Next Gen Radio System

Customer Design Review Submittal Analysis
Third Party Review

Marin Emergency Radio Authority (MERA)

May 18, 2020

Figure 1. Possible path interference issue

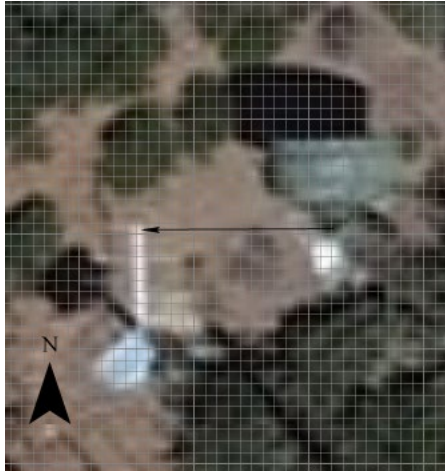
- b. Microwave at ST# 16 to Stewart Point seems to be pointing too close to ST# 15. It should be verified if ST#16 will not have any interference. Alternatively, the microwave paths can be switched between ST#15 and ST#16. Figure 1 below shows line at 270 degrees and it is clear there is another antenna on ST#16 that could potentially interfere with path from ST#16.

Figure 2. Problem areas still missing coverage

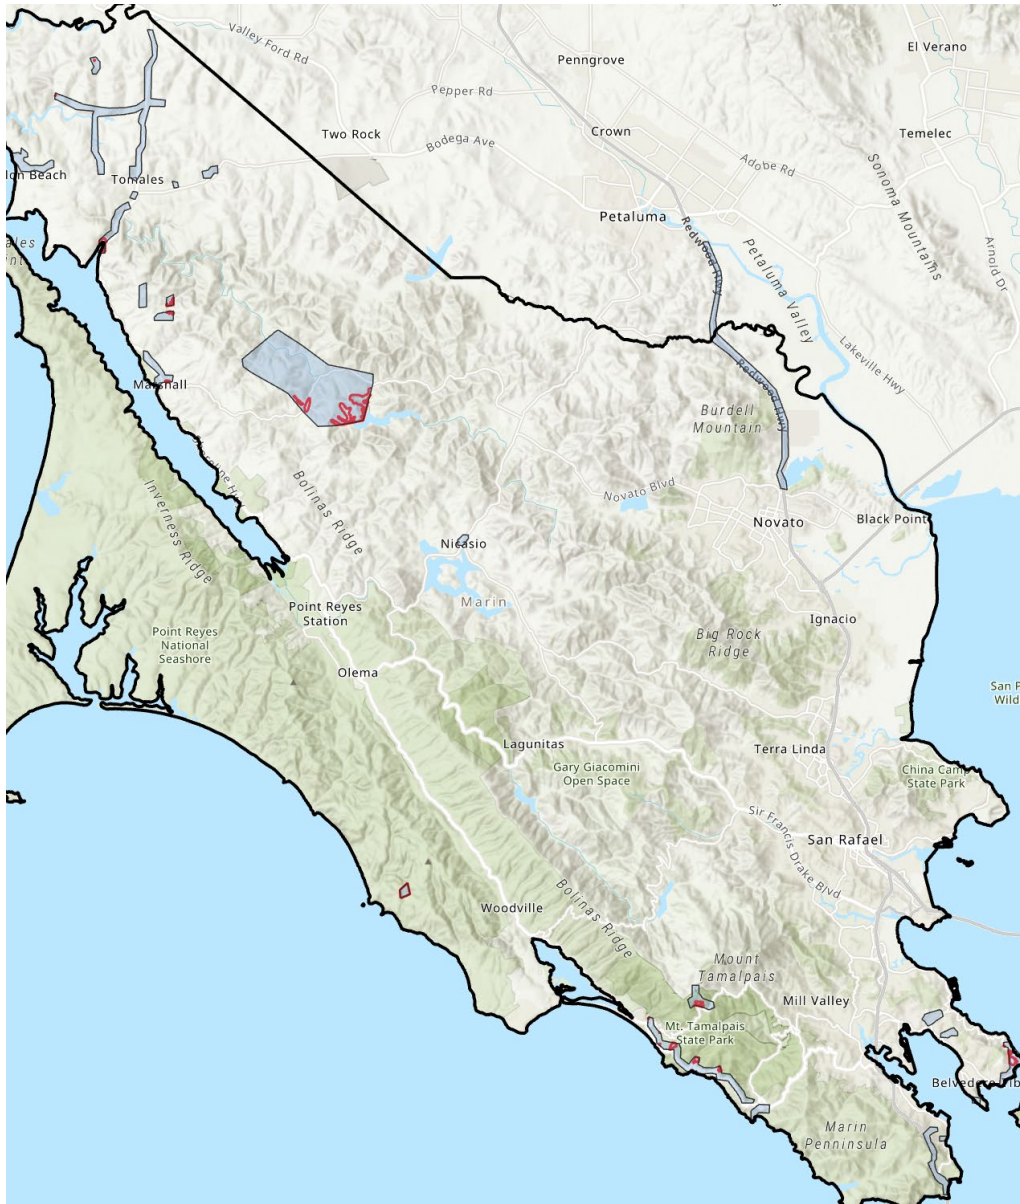
1. AECOM was informed through questions answered by Motorola that this file illustrates the portable on-street coverage. "Motorola_MERA_CA_Marin_Post-sale Design_CountyWide_30MAR18_V1.0_SG.kmz".
2. Please see our coverage **recommendation** in CDR 02-28 on how to further understand and solidify the coverage commitment conveyed in this map.
3. Note: The Portable on the street coverage shown in the kmz file still has some gaps in the known problem areas identified in the RFP. These gaps are shown in Figure 2 below by red outlines within the light blue shape representing the problem areas from the RFP. We **recommend** these potential gaps be reviewed carefully to verify they will not cause operational issues.
